# Submission in respect of the proposed Snowy 2.0 Main Works

by Robert Jenkins, Cooma  
4 November 2019

Fig 3 - Weekday peak hour intersection traffic volumes (Table 3-3) from Snowy 2.0 Main Works Traffic and Transport Assessment

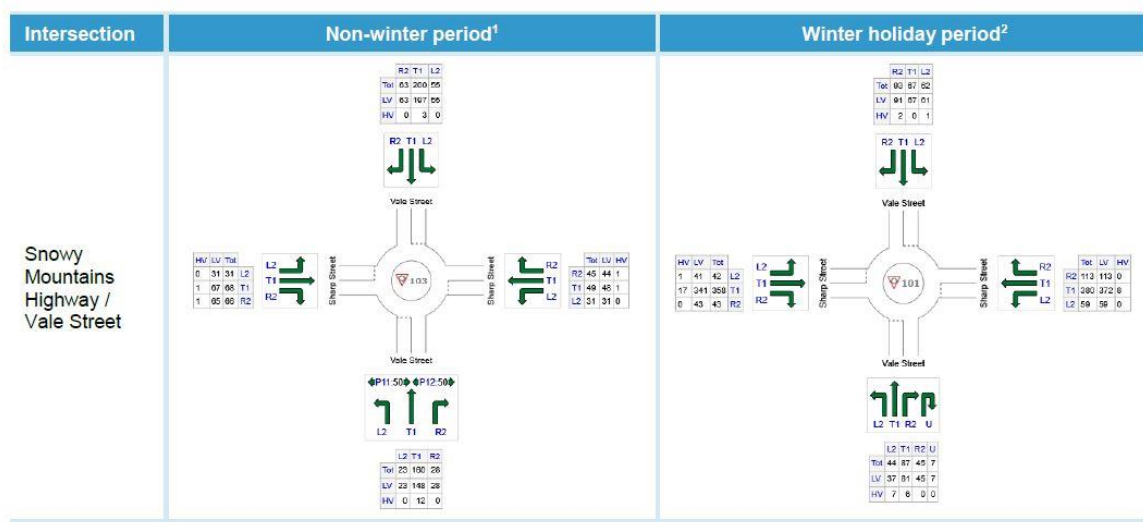
Figure 3 is an excerpt from Table 3-3 of the Snowy 2.0 Main Works Traffic and Transport Assessment and shows the peak hour traffic at the Sharp Street and Vale Street intersection. It demonstrates that almost all traffic is light vehicle. And taking account of the fact that HV vehicles include minibuses, light trucks (delivery vans) and coach buses, it is most probable that what HV vehicles were recorded did not include a single heavy truck.

The actual volume of heavy vehicle traffic on Sharp Street is light. Figure 3, peak hour traffic data at the Sharp Street/Vale Street intersection from the traffic assessment, shows just four heavy vehicles on Sharp Street across a whole hour. This is realistic.

Fig 4 - Average Total Project Traffic from Annexure D Construction traffic volumes of the Snowy 2.0 Main Works Traffic and Transport Assessment

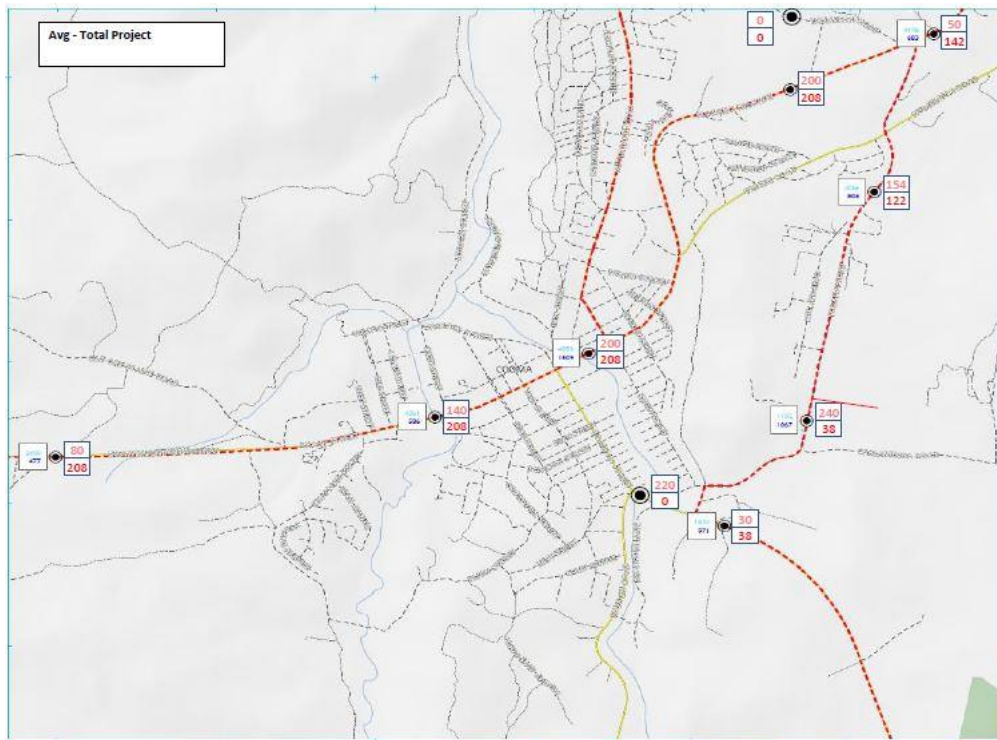
Figures 4 and 5 show the average daily project traffic along Sharp Street will include 208 heavy vehicles and the peak daily traffic will include 390 heavy vehicles. These are one-way movements – almost all heavy vehicles will have a return journey. In total, therefore, Sharp Street will have to cope with over 400 daily heavy vehicle movements on average across the project and almost 800 daily heavy vehicle movements at the peak of the project.

The traffic assessment notes approximately 20% of project traffic would be at night. Taking 80% of the traffic and based on 10 hours of daytime, at average times, there would be over 30 heavy vehicles along Sharp Street every hour. At peak times, 60 heavy vehicles.

Fig 7 – RMS average daily traffic count on Monaro Highway, 400m east of Polo Flat Road

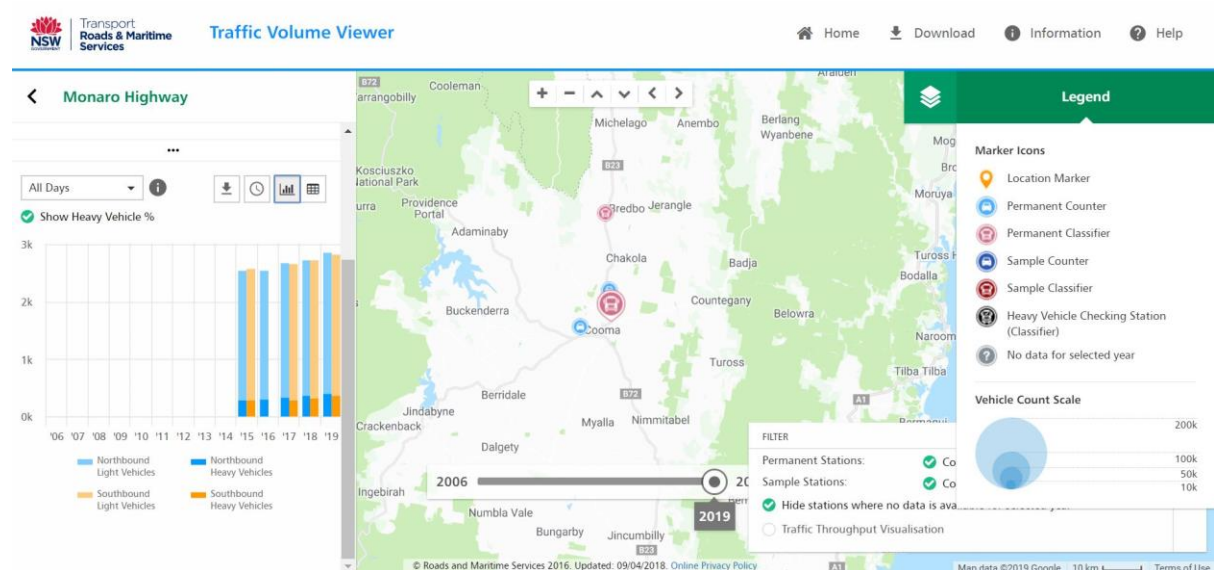
The RMS average daily traffic count for 2019 is 5704 total vehicles which includes 790 heavy vehicles.

The EIS baseline average daily traffic volumes are clearly inconsistent with the volume measured at the RMS permanent counter. In particular, the EIS shows 1509 heavy vehicles per day on Sharp Street on the north eastern approach into Cooma and 586 heavy vehicles per day on the south western approach to Cooma. Assuming the majority of 1509 vehicles travel across 10 hours of the day, the hourly volume of heavy vehicles on Sharp Street is 150, or a heavy vehicle less than every 30 seconds across a whole day. This is not correct and calls into question conclusions reached in the traffic assessment.

Fig 9 - Average Total Project Traffic from Annexure D Construction traffic volumes of the Snowy 2.0 Main Works Traffic and Transport Assessment

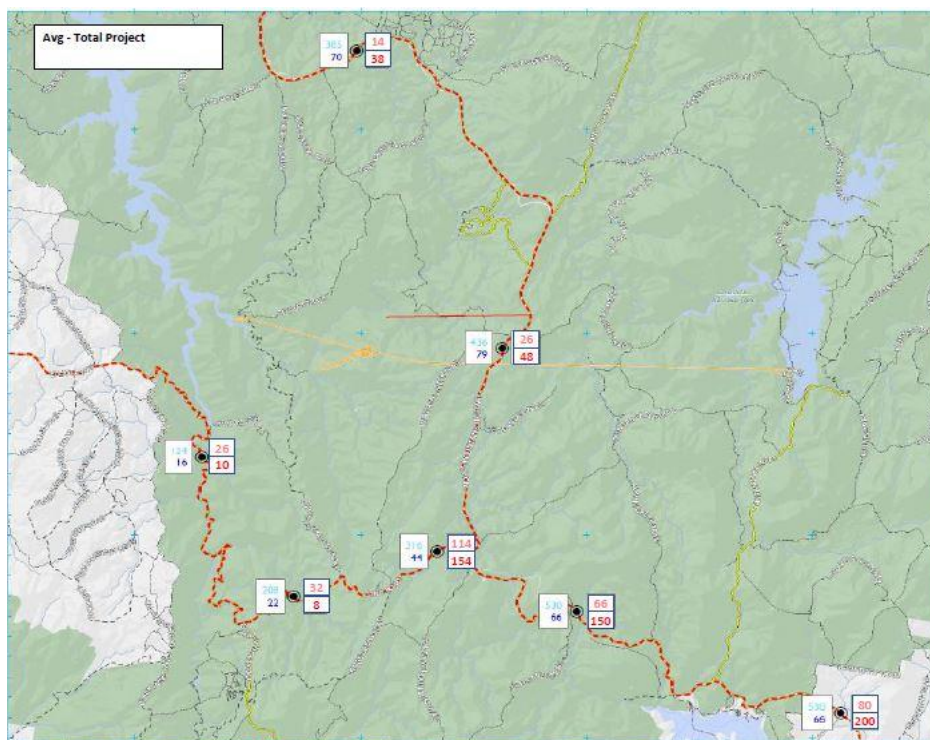
These show the average daily project traffic along the Snowy Mountains Highway before reaching the Kosciuszko National Park boundary will include 200 heavy vehicles and the peak daily traffic will include 362 heavy vehicles. These are one-way movements – almost all heavy vehicles will have a return journey. In total, therefore, the Snowy Mountains Highway will have to cope with 400 daily heavy vehicle movements on average across the project and 720 daily heavy vehicle movements at the peak of the project.

The traffic assessment notes approximately 20% of project traffic would be at night. Taking 80% of the traffic and based on 10 hours of daytime, at average times, there would be over 30 heavy vehicles along the Snowy Mountains Highway every hour. At peak times, 60 heavy vehicles.
